Safety Notice

SUBJECT: 'X' Style Harness Redesign

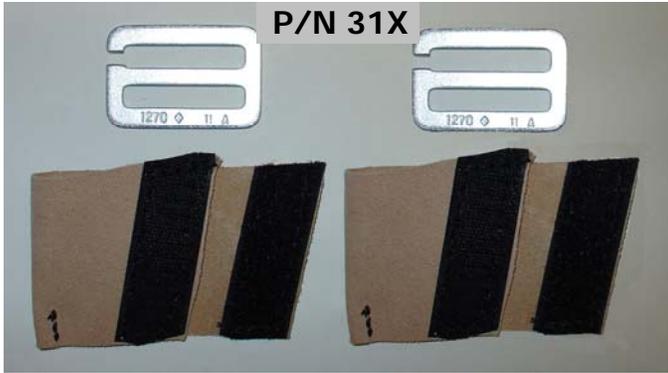
It has come to our attention that the force of a fall may cause the dorsal attachment/sliding chafe (Fig. 'D') on the back of an 'X' style harness to slide up, resulting in the shoulder straps putting excess pressure on the sides of the user's neck, which, under certain circumstances, could result in serious injury or death.

For those non-BuckFit 'X' style harnesses manufactured prior to February 2011, Buckingham has developed a field retrofit kit available to users of this design 'X' style harness. The specially designed kit, P/N 31X (Fig. 'E'), secures the dorsal attachment/chafe to the shoulder straps (Fig. 'F'), and prevents it from sliding up in the event of a fall. This P/N 31X retrofit kit is available at no charge to users of the subject harness.

To prevent this from occurring, Buckingham implemented a modification to its 'X' style harnesses manufactured on and after February 2011 by (1) removing the chafe and (2) permanently stitching the dorsal attachment to the shoulder straps (Fig. 'C').

4. Upon receipt of the retrofit kits, remove all representative 'X' style harnesses within your possession from service and install the P/N 31X kit (Fig. 'F').
NOTE: As an alternative to the field retrofit kit, you may return your harness to Buckingham for chafe removal and permanent stitching of the dorsal attachment to the shoulder straps. Contact Buckingham for a Returned Goods Authorization Number.
